Video Products Technical Bulletin 30-2015-007

SUBJECT: PARTS REGISTRATION—BHS1 AND BHS2
BOARDSMODEL: **BKM-341HS**
BKM-341HS**DESCRIPTION**

Figure 1

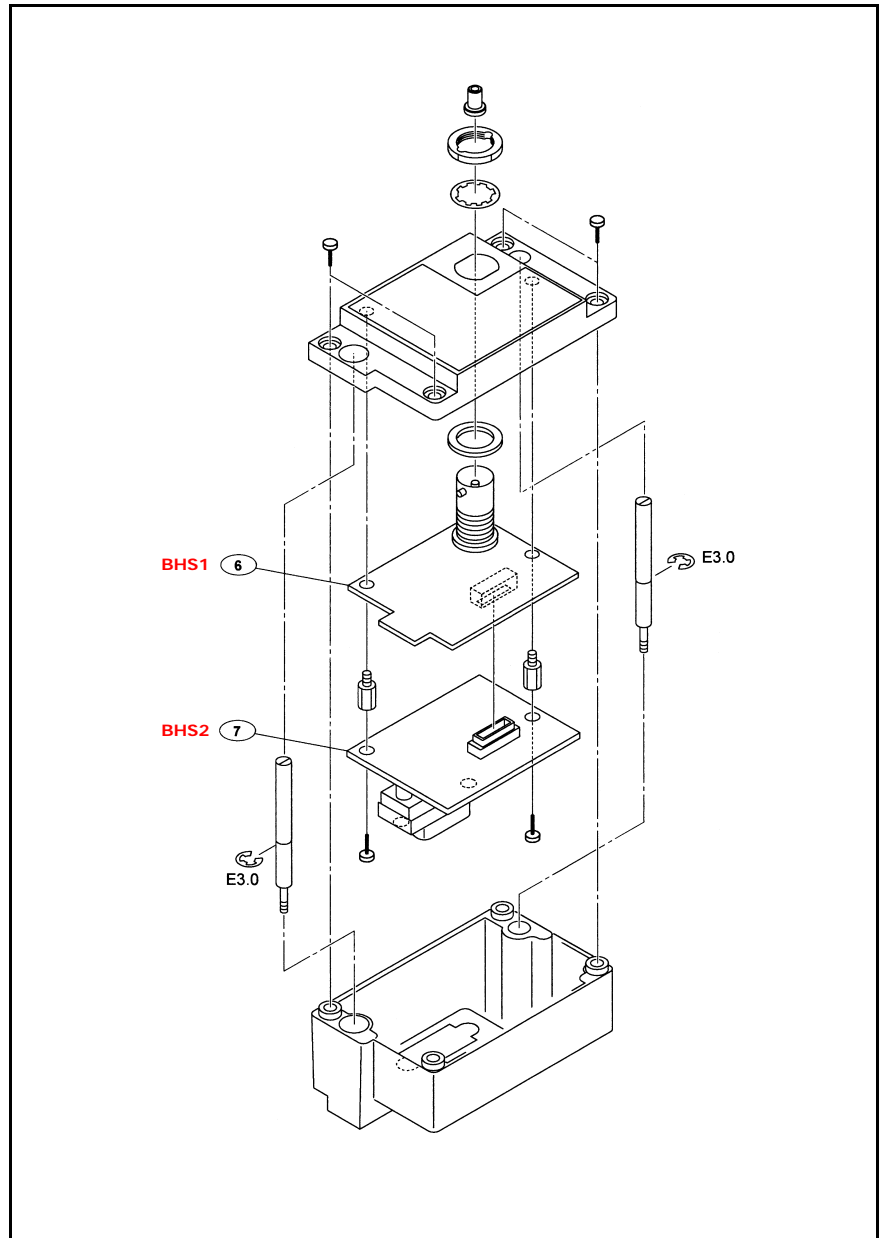
New BHS boards are available. (See Table 1 and Figure 1.)

- Former and new boards are not compatible. When replacing a former with a new board, replace both boards simultaneously.
- New boards are installed in units with the following serial numbers:
 - 3,002,144 and Higher
 - 5,000,351 and Higher*
- New boards have the following indications printed on the board:

Model	Indication
BHS1	4H.1D756.S01
BHS2	4H.1D712.S01
